SABER TOOTH BEARING INSTALLATION

ORIGINAL HUB
210079

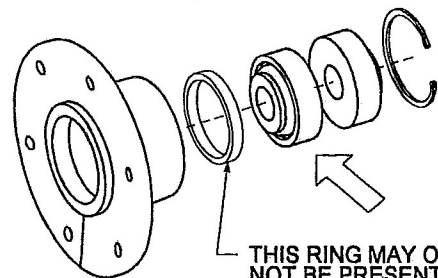
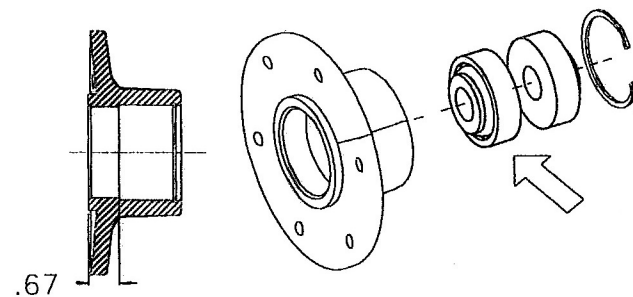
NOTE: THE HUBS HAVE A SLIGHT BUT SIGNIFICANT DIFFERENCE IN THEM.

THIS RING MAY OR MAY
NOT BE PRESENT, DE-
PENDING ON WHEN YOU
RECEIVED YOUR HUB.

REVISED HUB
210079A

BE SURE TO INSTALL THE NEW BEARINGS IN
EXACTLY THE SAME ORIENTATION AS THE OLD ONES.

WITH REVISED HUB
